Leather seats, improvements on wrinkles and wear

REF NO:
TJ 32005.1.0

Nappa leather improvements

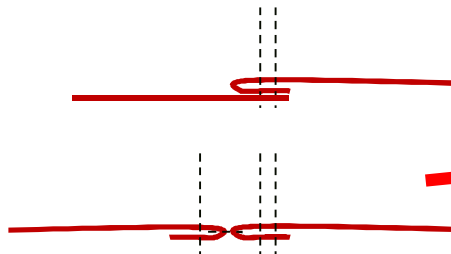
Issue:

Early wear on top of bolster seam and cushion.
(Cloth is folded to one side, which gives a higher level.)

Solution:

New seam on bolster.
(Cloth is now folded to both sides. Gives a flat connection.)

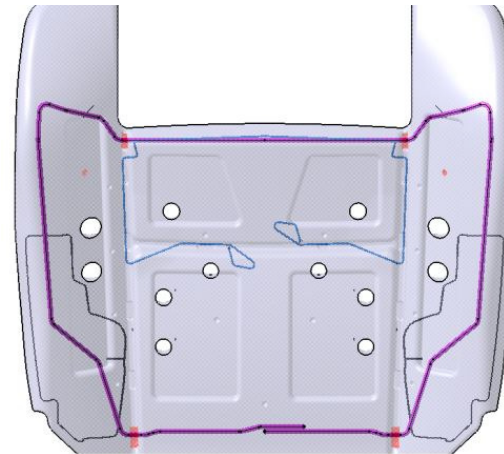
**Issue:**

Early wear on outside of bolster cushion.

**Solution:**

Steel wire embedded in the foam.
Prevents the side bolster to fold during egress. Also reduces wrinkles on the inside of side bolster.

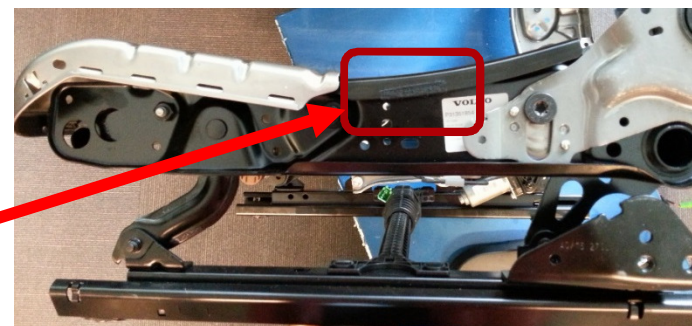
Issue:

Side bolster wrinkles (Clist comes loose and a white piece can be seen.)

Solution:

Elastic material in seam as improvement.
(Tape can be applied on older seats for better grip)
